**SERVICING / WASTE
MANAGEMENT PLAN
&
Independent Development
Road Safety & Quality
Audit (incl Cycle/Walking)
(Appendix B)**

**Proposed Student
Accommodation
Development**

**139-149 North King St.,
Dublin 7.**

Title: **Road Safety Audit (Stage 1),
Cycle Audit and Walking Audit.**

4.1 Problem

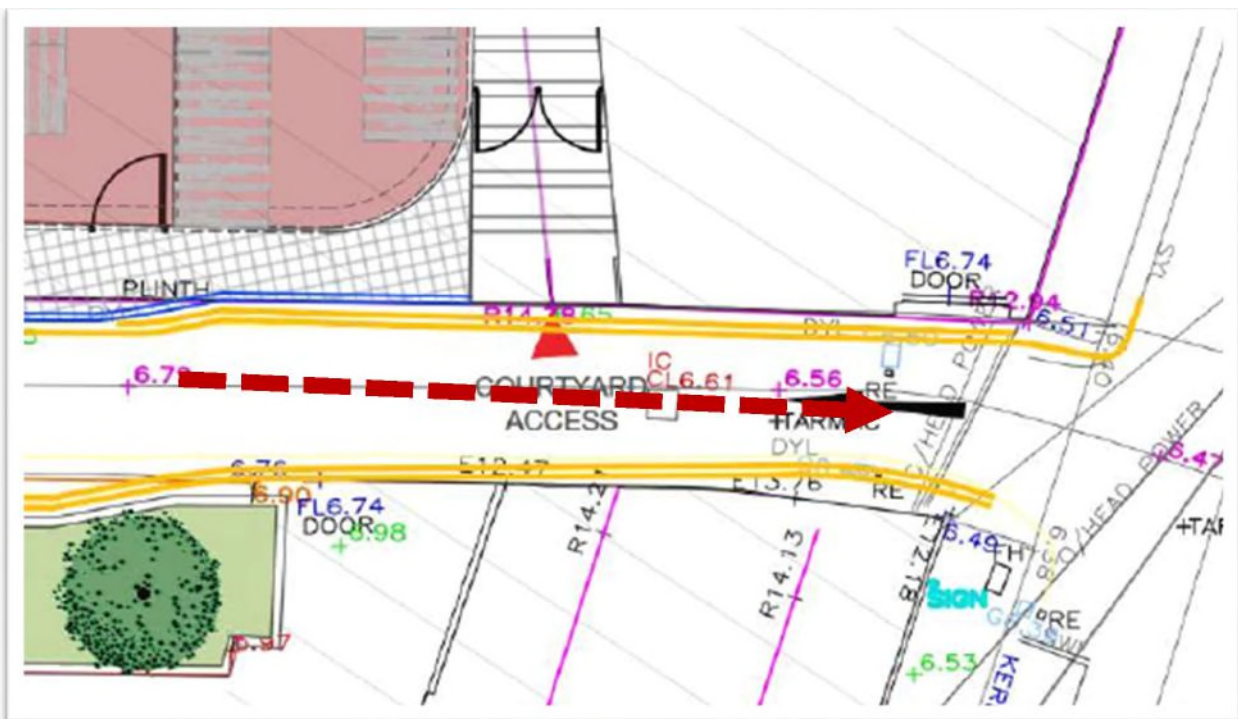
Drawing NRB RFI-001

Cyclists from the new development will travel contra flow on Brown Street onto Bow Street from the courtyard access or the long term bicycle shelter. This could lead to collisions with vehicles turning into Brown Street from Bow Street.

It is recommended that provision be made for contraflow cycling including signage road marking, coloured surfacing and speed limit.

Paragraph No. in Safety Audit Report	Problem accepted (yes/no)	Recommended measure accepted (yes/no)	Alternative measures (describe)	Alternative measures accepted by Auditors (Yes/No)
4.1	Yes	Yes		
4.2	Yes	Yes		
4.3	Yes	Yes

4.2 Problem

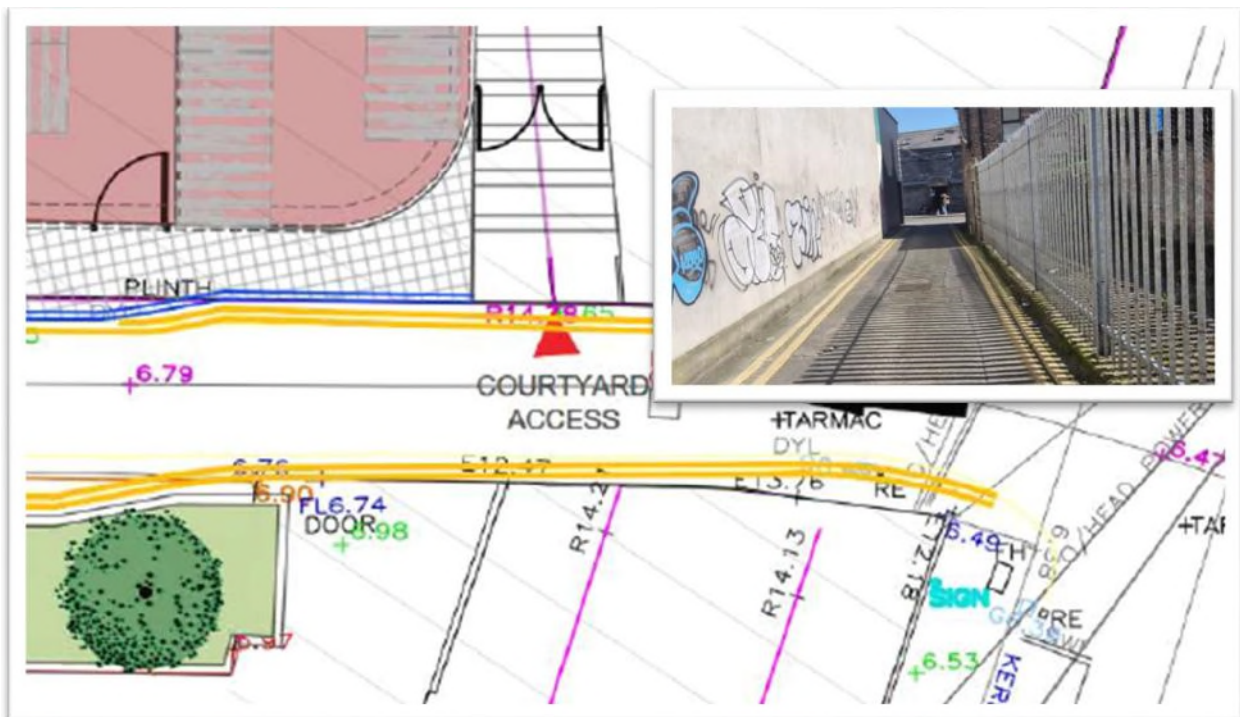
Drawing NRB RFI-001

Brown Street will not have a footpath at the section from the courtyard access to Bow Street. This area will get increased pedestrian use due to the proposed development. The drawings suggest priority for vehicles with the standard carriageway surfacing and road markings. There is a risk that drivers will travel too fast and not expect to share space with pedestrians and cyclists. There is also a risk that the improved Brown Street will be used as a rat-run when drivers know they can avoid the Bow Street/North King Street junction which is tight and can have delays. Those using it as a rat-run may also travel at excessive speed for a space shared with vulnerable road users.

It is recommended that the street be designed as a shared use street with a raised entry off Bow Street, contrasting surfacing and suitable signage and speed limit.

4.3 Problem

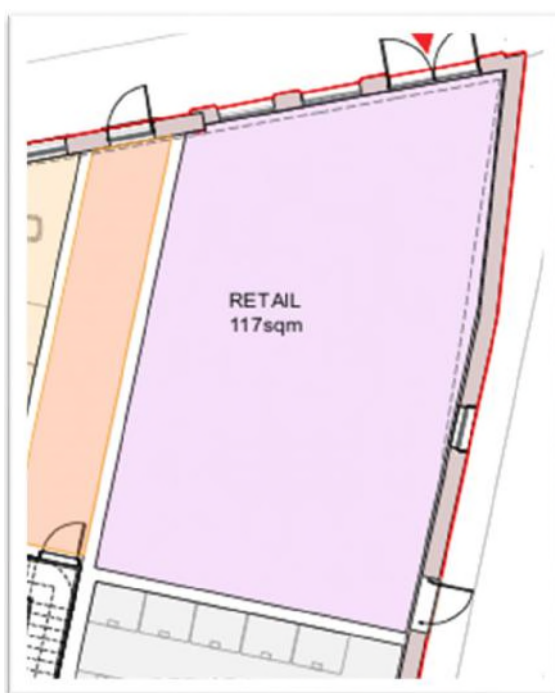
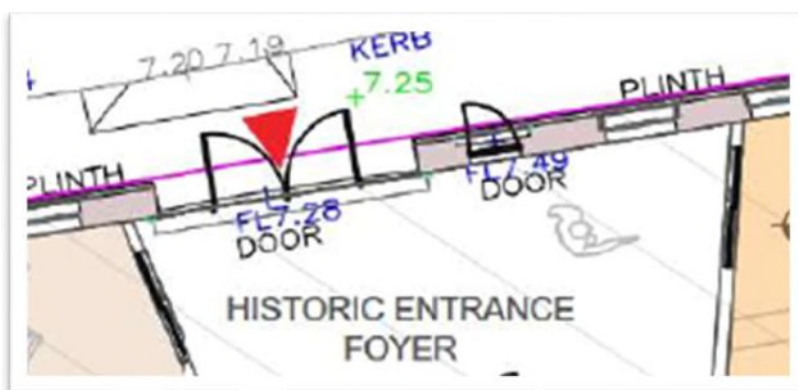
Drawing NRB RFI-001

Many doors are shown on the drawing to open onto the footpath network on Bow Street and North King Street. This could lead to collisions with pedestrians walking by on relatively narrow footpaths.

It is recommended that recessed doorways be provided for doors that will be used regularly.

5.1 Issue

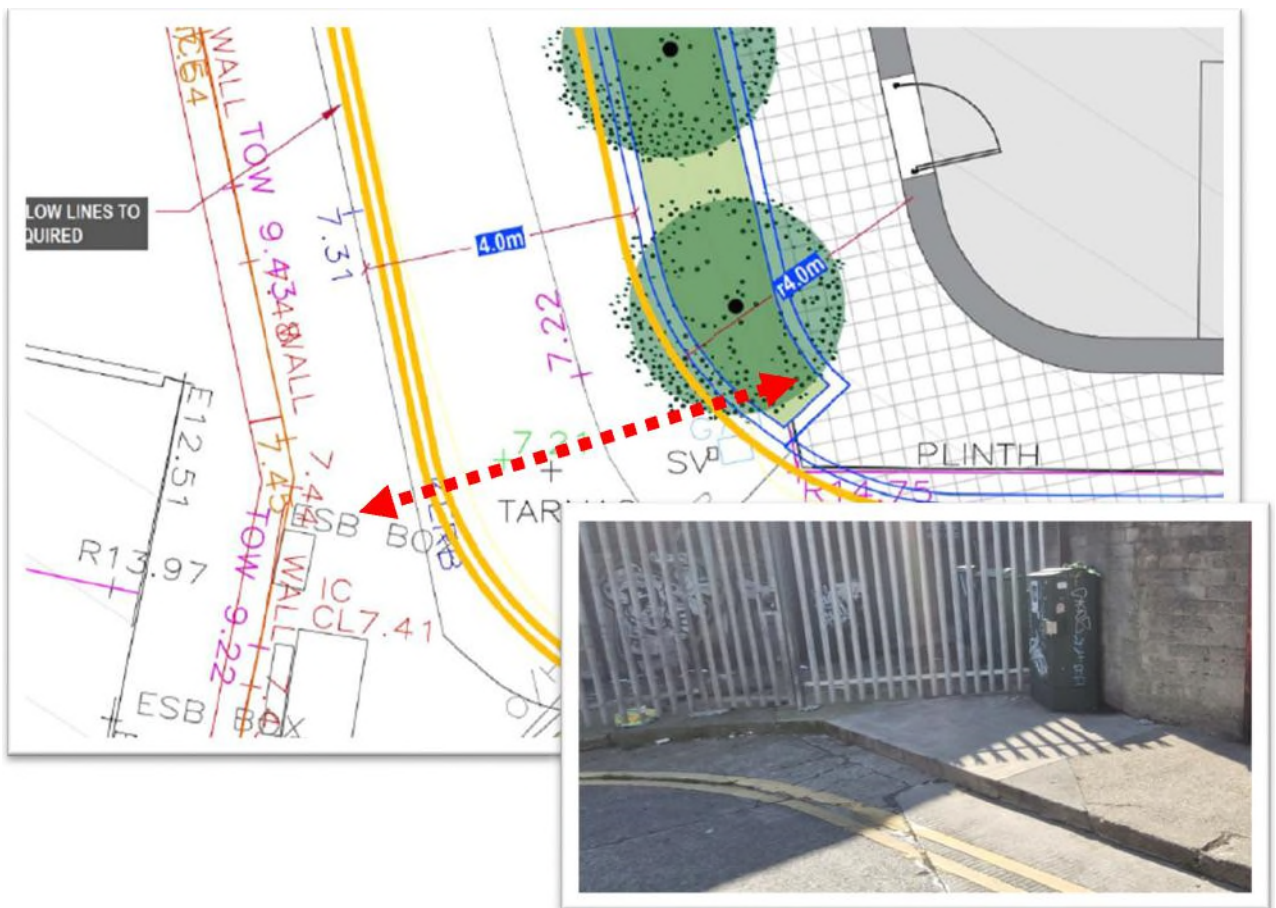
Brown Street.

If pedestrians travel down the footpath on Brown Street from North King Street there is no provision for them to cross to the new footpath on the opposite side at the bend.

It is recommended that a crossing point be provided with dropped kerbs and tactile paving. The crossing point should be at a location with suitable visibility for approaching drivers.

Paragraph No. in Safety Audit Report	Problem accepted (yes/no)	Recommended measure accepted (yes/no)	Alternative measures (describe)	Alternative measures accepted by Auditors (Yes/No)
5.1	Yes	Yes		
5.2	Yes	Yes		
6.1	Yes	Yes – internally Bike Parking will be adjusted to meet NTA CDM Guidance needs		
6.2	Yes	Yes – as part of Planning process Cargo bikes will be accommodated

6.1 Issue

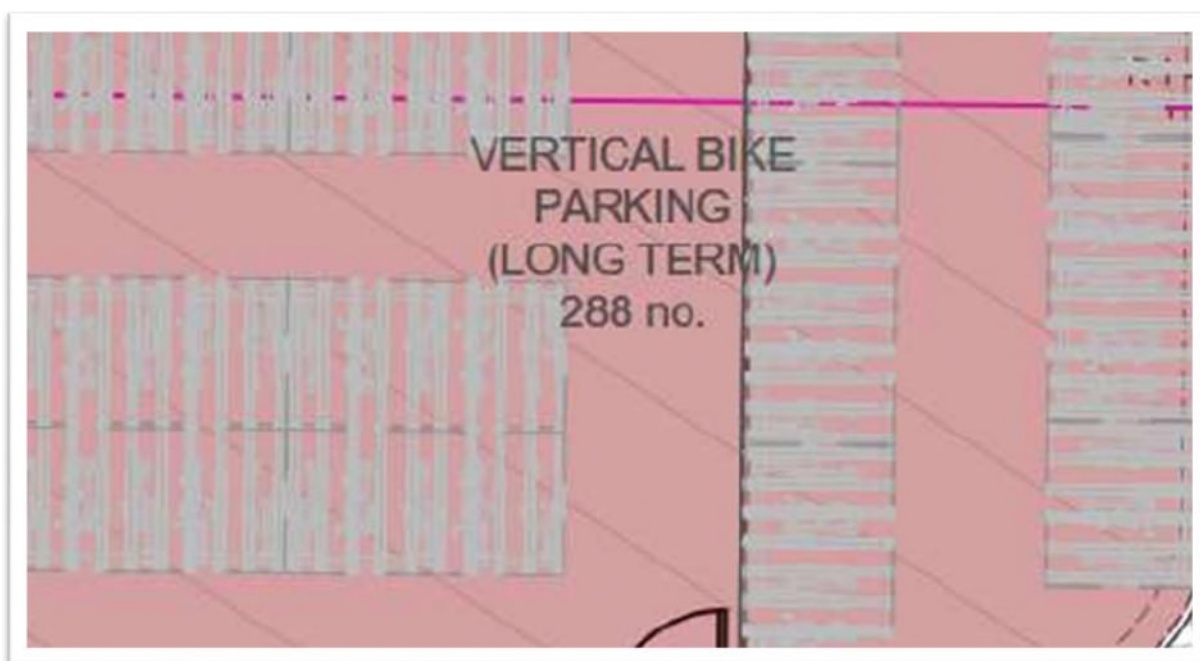
Long term vertical bicycle parking.

It is unclear if there is sufficient space between rows of bicycle parking for the higher bikes to be lowered and taken off the stands without colliding with the adjacent bike stands.

Ensure sufficient space is provided.
